SUBJECT: SAFETY EVALUATION OF RELIEF REQUESTS FOR THE SECOND
10-YEAR INTERVAL INSERVICE TEST PROGRAM PLAN, SEABROOK
STATION, UNIT NO. 1 (TAC NO. MA8532)

SAFETY EVALUATION BY THE OFFICE OF NUCLEAR REACTOR REGULATION
RELATED TO THE INSERVICE TESTING PROGRAM, SECOND 10-YEAR INTERVAL
NORTH ATLANTIC ENERGY SERVICE CORPORATION

SEABROOK STATION, UNIT NO. 1

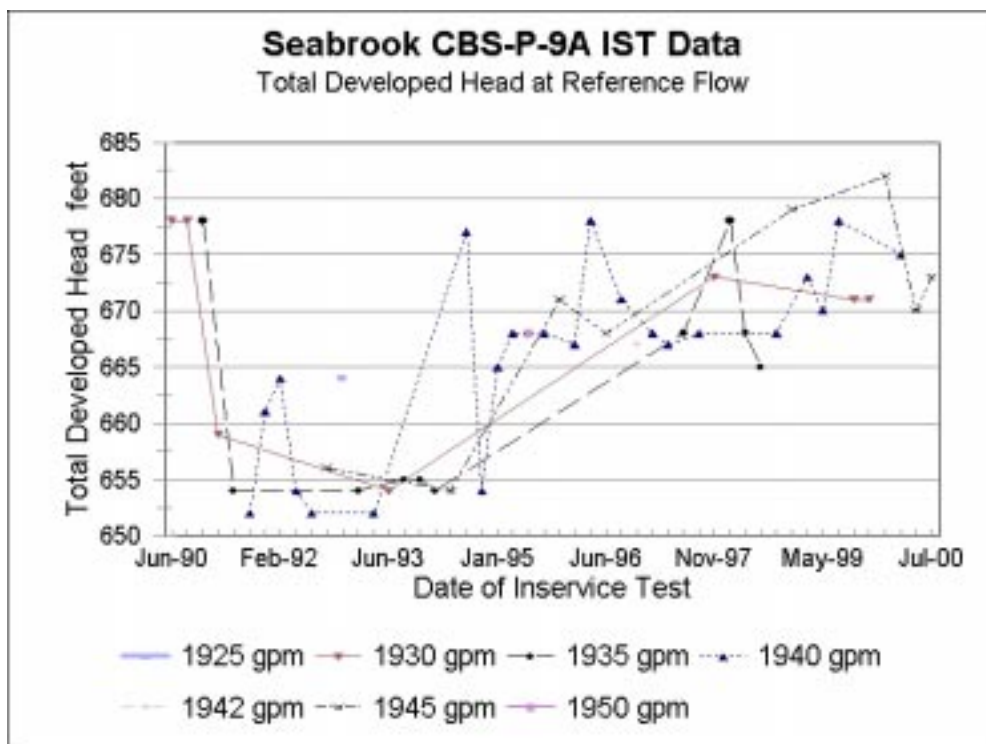
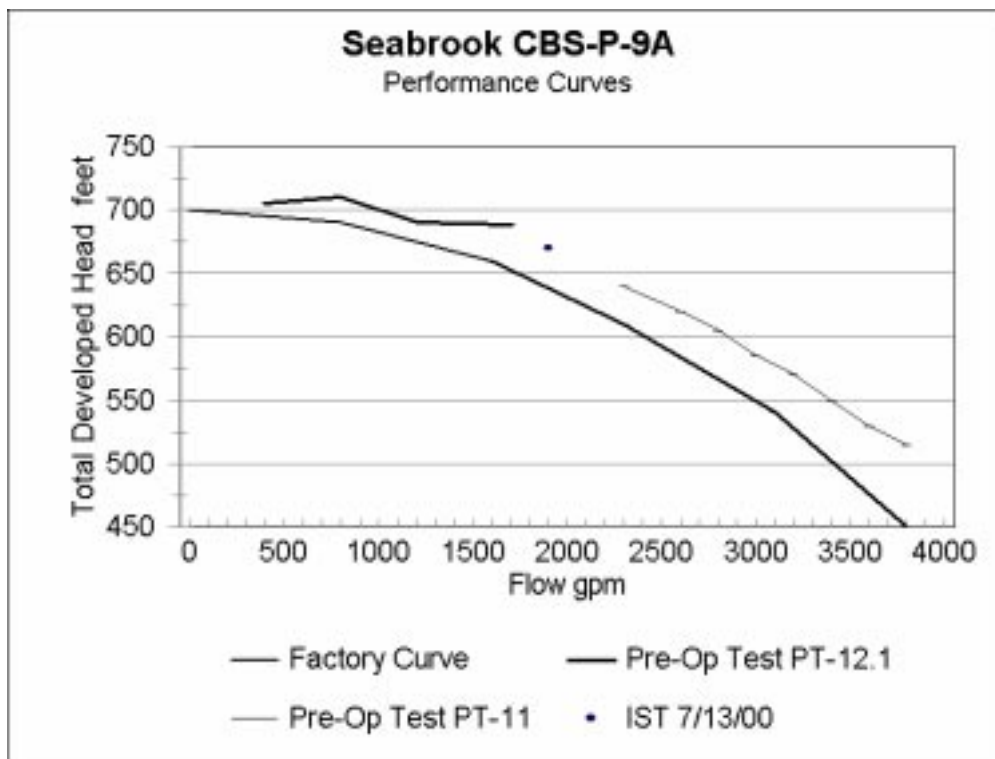
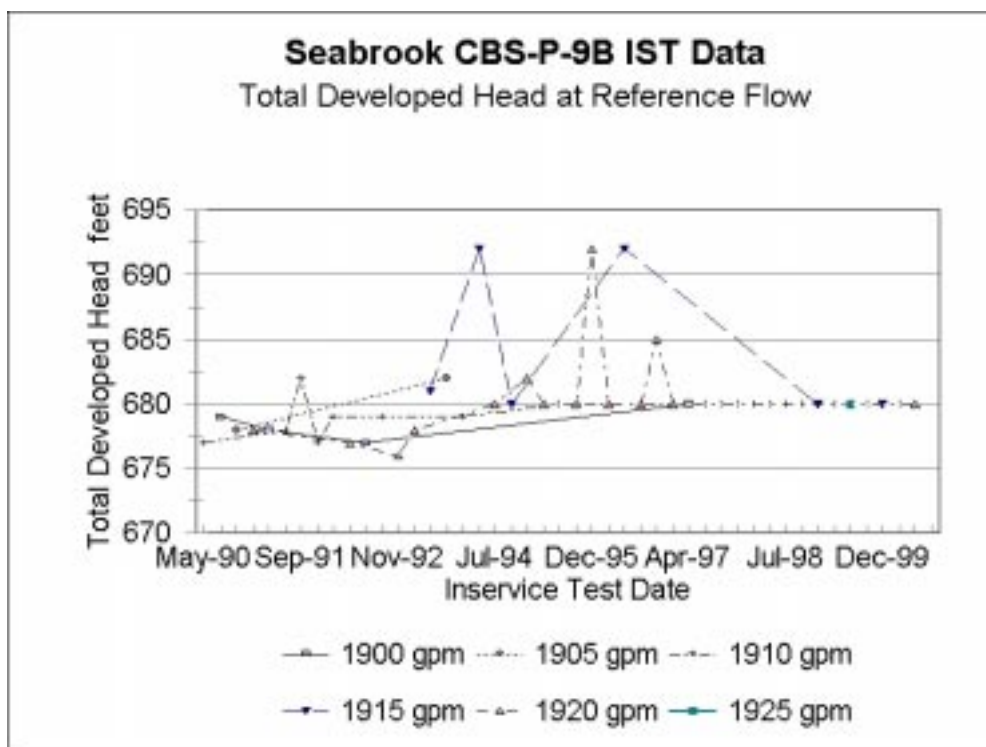
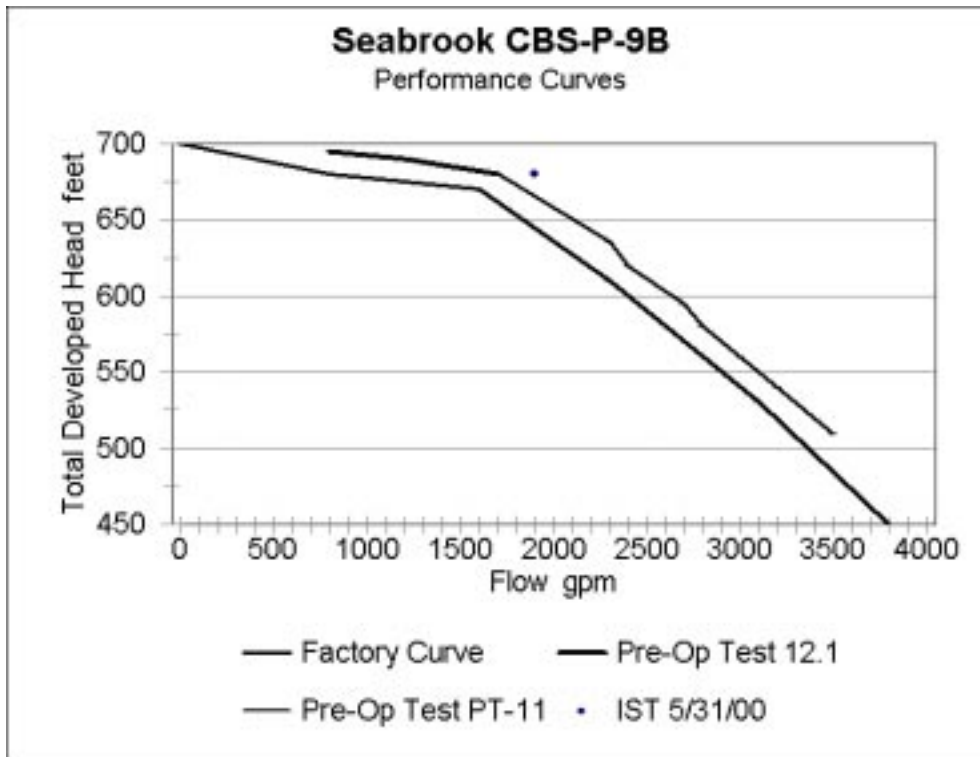
The first graph, reproduced from curves provided by the licensee in its submittal dated August 18, 2000, compares performance data for pump CBS-P-9A taken both at the factory and during pre-operational testing with a recent inservice test hydraulic data point. The second graph, plotted from data provided in the licensee's submittal dated September 8, 2000, consists of performance data taken from all inservice tests performed on CBS-P-9A. Different reference flow rates are plotted on the same graph according to the date the test was performed. At higher flow rates, a lower pump head is expected. The next two graphs provide similar data for containment spray pump CBS-P-9B.

In order for the licensee's proposed alternative to provide an acceptable level of quality and safety, the pump test performed at 63% of the pump BEP must be able to demonstrate that degradation will be readily detected. The optimum performance point to detect pump degradation is near the pump's design flow rate because, as previously stated, this area of the pump curve is considered to be the most representative of the pump's design performance characteristics. Changes in hydraulic performance near the design point would not be as readily masked as they would be at conditions near the shutoff head of a centrifugal pump.

Based on the factory curves, the shutoff head of both containment spray pumps is 700 gpm. It is also noted that the pre-operational performance curves are offset from the factory curve, possibly due to higher system resistance and methods of collecting and reducing the performance data. The representative IST points plotted on these two curves either coincide or are above the pre-operational performance curves. Another observation regarding the performance curves is that the slope of the pump/head curve measured at the factory and the pre-operational test curves are very small at flow rates up to 2,000 gpm. As an example, for CBS-P-9B, the total developed head at approximately 1,900 gpm is 680 feet. This is less than 1% of the shutoff head of the pump. At 2,400 gpm, the curve plotted using data from pre-operational test PT-11 shows that the total developed head is approximately 620 feet or 12% below the shutoff head of the pump. At 3,000 gpm, the total developed head drops to approximately 560 feet or 20% below the shutoff head.

As stated above, the IST data for both pumps was graphed such that for a particular flow rate, the corresponding total developed head was plotted on the date of the test. The intent of the plot is to provide trend data of total developed head at each measured flow rate for both containment spray pumps. The expected result was that at higher flow rates, there would be a lower pump total developed head. This would provide an indication that the pumps were being tested in an area of the curve such that the intent of the comprehensive test would be satisfied. In examining the IST data graphs for both CBS-P-9A and CBS-P-9B, the only trend that can be

inferred is that the variation in pump total developed head decreases significantly in tests after 1995. The plot of CBS-P-9A yielded no similarity in pump head at constant flow rates. In addition, in testing since 1997 for CBS-P-9B, despite a variation in the measured flow rate of 15 gpm, the total developed head is a constant 680 feet. These results may be due to instrument accuracy. Another possible explanation is the region in which the pump is being tested is insensitive to small variations in pump flow because the pump is operating near its shutoff head.

Based on its analysis of the IST data, the staff finds that containment spray pump testing using the bypass line does not provide any additional information when compared to pump testing at much lower flow rates. In addition, the licensee has not proposed any compensatory actions to supplement the testing strategy for the containment spray pumps. Therefore, the staff does not find an adequate basis exists to authorize the alternative as proposed by the licensee. However, considering that an evaluation of the containment spray pump testing shows repeatable results using the current Code test strategy using a flow test loop which allows pump testing at significant flow rates (albeit at a performance point that is approximately within 1% of pump shutoff head), the staff finds that the licensee's alternative provides sufficient assurance of operational readiness of the pumps to authorize the alternative for an interim period to allow time for the licensee to reevaluate its proposed alternative testing. The proposed alternative provides sufficient assurance of operational readiness during the interim period because flow testing of the containment spray pumps will be performed quarterly at significant flow rates and that the licensee has not identified any recent maintenance or testing issues with these pumps.

During the interim period, the licensee should reevaluate the current testing to assess the ability to detect degradation as was intended by the OM Code-1995 pump test strategy. This may entail more detailed analysis of the IST data, consultation with the manufacturer, or running additional tests as appropriate. If the licensee cannot further demonstrate that the proposed testing is an acceptable alternative, then appropriate compensatory actions should be proposed to supplement the alternative testing. Possible strategies or combinations of strategies include: 1) testing at the BEP on a much longer interval; 2) commitment to perform additional performance monitoring on the containment spray pumps; 3) adjustment of acceptance criteria; and/or 4) continuation of the current Code testing, including taking overall vibration data quarterly.

The proposed alternative to the Code reference value requirements of ISTB 4.3.e(1) for the containment spray pumps CBS-P-9A and CBS-P-9B is authorized for an interim period of 2 years pursuant to 10 CFR 50.55a(a)(3)(i) based on the alternative providing an acceptable level of quality and safety. During the interim period, the licensee should reevaluate the current testing to assess the ability to detect degradation as was intended by the OM Code-1995 pump test strategy. If the licensee cannot further demonstrate that the proposed testing is an acceptable alternative, then appropriate compensatory actions should be proposed to supplement the alternative testing.
